CITY OF ALBUQUERQUE

**Re: Sage Plaza Storage
9850 De Vargas Rd SW
30-Day Temporary Certificate of Occupancy
Transportation Development Final Inspection
Engineer's Stamp dated 01-31-24 (M09-D012B)
Certification dated 03-12-2025**

**RE: AA APPROVED TRAFFIC CIRCULATION LAYOUT
REQUEST FOR TEMPORARY CERTIFICATE OF OCCUPANCY
9850 DE VARGAS RD SW ALBUQUERQUE NM 87121**

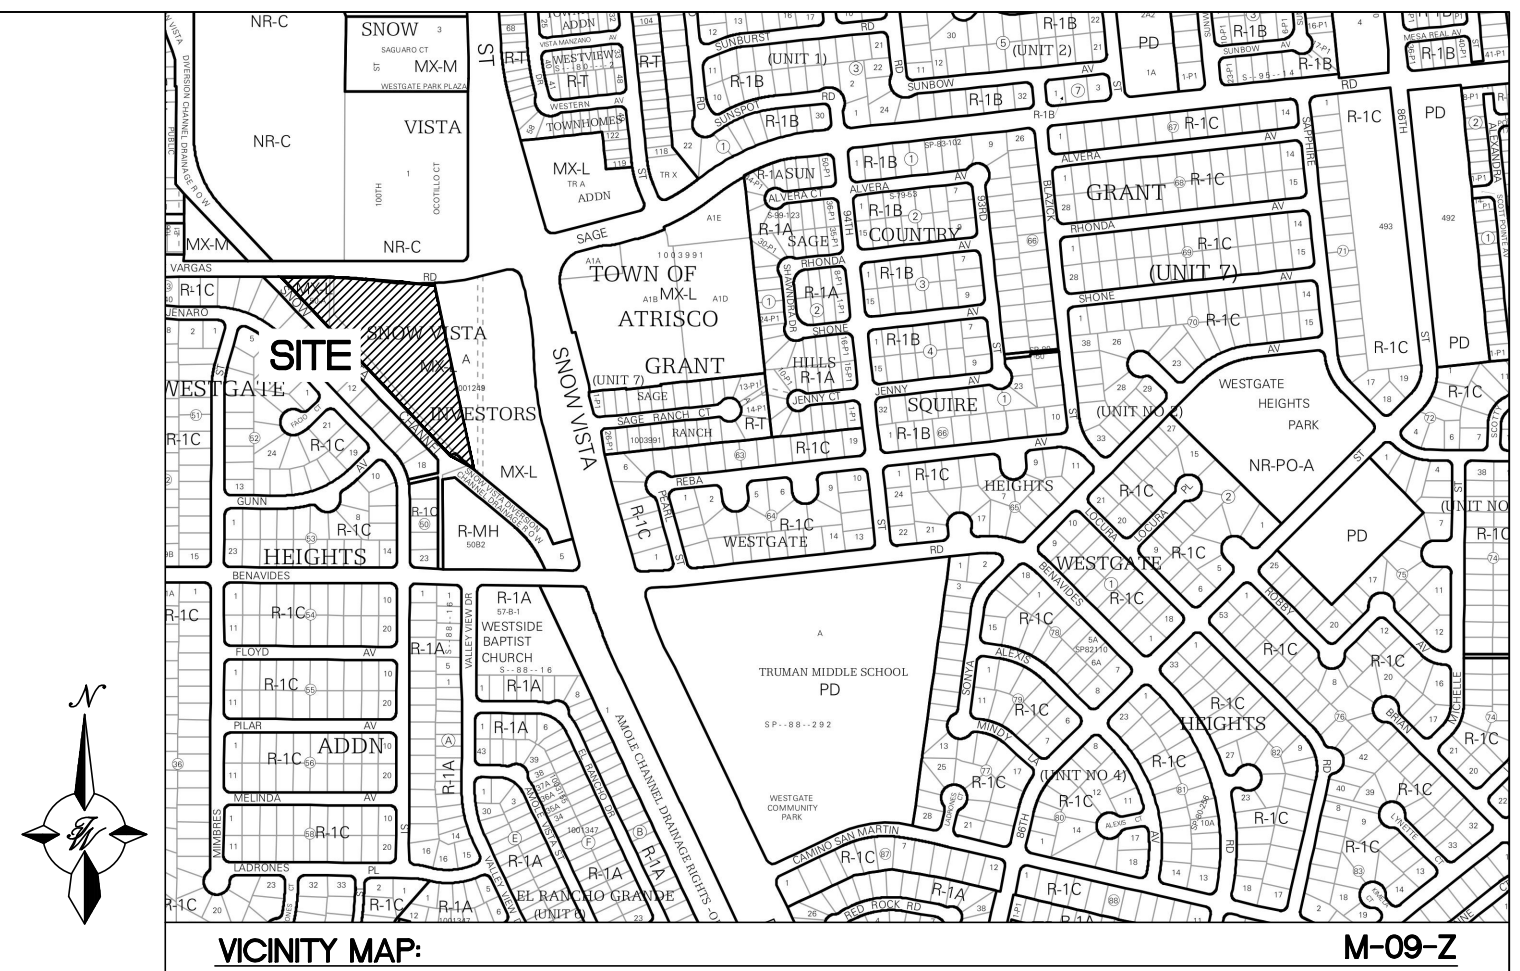
Enclosed, please find the Letter of Engineer's Certification and the as-built AA Traffic Circulation Layout. Therefore, we request approval of the as-built AA Traffic Circulation Layout and issuance of the Temporary Certificate of Occupancy to allow the contractor to complete the corrections as noted below.

- 1) Install Bicycle Racks at the Main Entrance
- 2) Install Stop Bar Stripe at the Access Roadway to the facility
- 3) Install an ADA Compliant Pedestrian Crossing at the North Access entrance.

Prior to the issuance of a permanent Certificate of Occupancy, the following items must be addressed:

- Complete site construction, and remove fencing from the site.
